Intel[®] Pentium[®] II Xeon[™] Processor Specification Update

Release Date: August 2000

Order Number: 243776-023

The Pentium[®] II Xeon processor may contain design defects or errors known as errata which may cause the product to deviate from published specifications. Current characterized errata are documented in this Specification Update.

Figure 2. Workaround Flowchart: SMBALERT#-Driven System

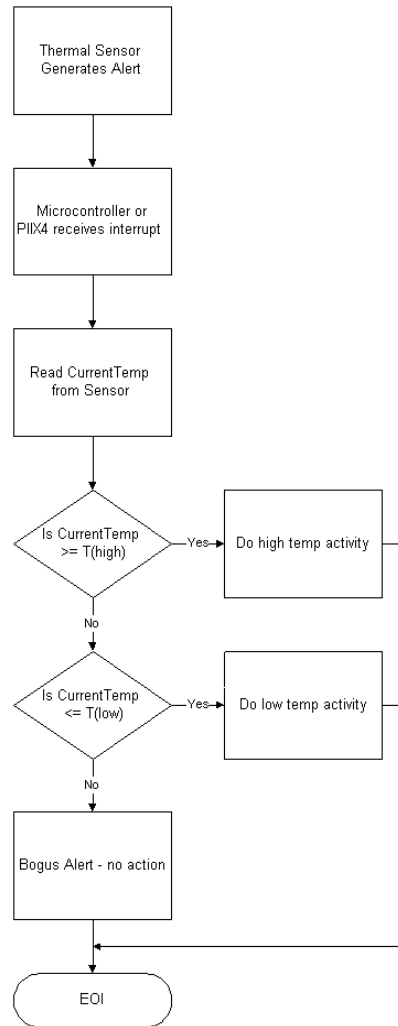
D30. Thermal Sensor May Assert SMBALERT# Incorrectly

Under the conditions described below, the thermal sensor incorrectly generates the SMBALERT# interrupt. All of the following conditions must be met to trigger a false interrupt:

1. Before servicing an interrupt from the thermal sensor, read and compare the processor thermal reading with the threshold limits (T_{HIGH} or T_{LOW}). Figures 2 and 3 provide basic flowcharts for the implementation of this workaround in an interrupt driven system.

2. If the firmware implemented polls the Status Register only, then before taking any action, re-read the temperature register and do a comparison with the alarm threshold limits (T_{HIGH} or T_{LOW}) to determine if the value is actually still within the temperature window.
3. Use a temperature polling scheme to monitor the processor temperature
